# UNITED STATES PATENT AND TRADEMARK OFFICE

APPLICATION NO.	FILING DATE	FIRST NAMED INVENTOR	ATTORNEY DOCKET NO.	CONFIRMATION NO.
10/713,987	11/14/2003	Thomas E. Walker	LK9-03-001	1544
7590 02/28/2006 Laurence R. Letson P.O. Box 910567 Lexington, KY 40591			EXAMINER NGUYEN, PHONG H	
			ART UNIT 3724	PAPER NUMBER
DATE MAILED: 02/28/2006

**Office Action Summary**

## **DETAILED ACTION**

*Fig. 3a*

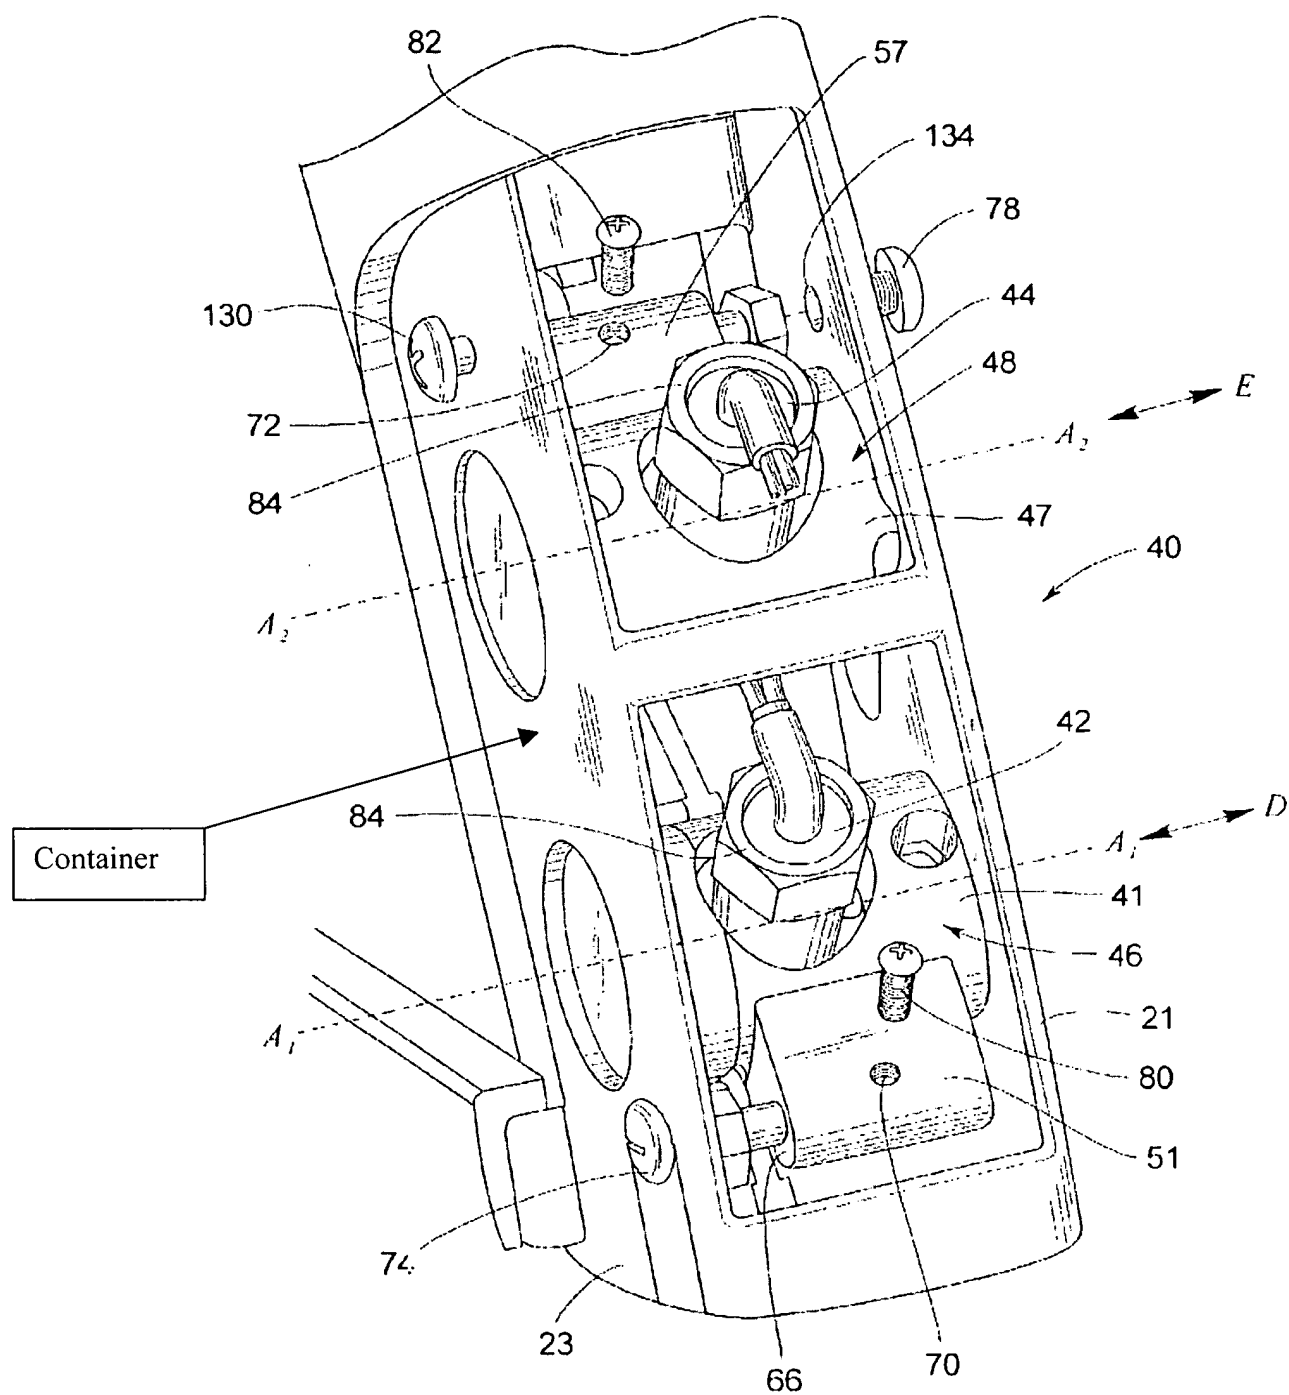
Regarding claim 3, Mori does not teach the Fresnel lens having a sinusoidal surface. Cook teaches a Fresnel lens having a sinusoidal surface (72 and 74). See Figs. 2 and 6. Therefore, it would have been obvious to one skilled in the art to make the Fresnel lens in Mori having a sinusoidal surface for prolonging the useful life of the lens since sharp edges in Mori's lens is easier to be broken.

Regarding claims 8-11, the spatial relationship of the container, the screws (78 and 130) and the saw blade is best seen in Figs. 1, 2, 3a, 3b, 5 and 6-9 in Garcia.
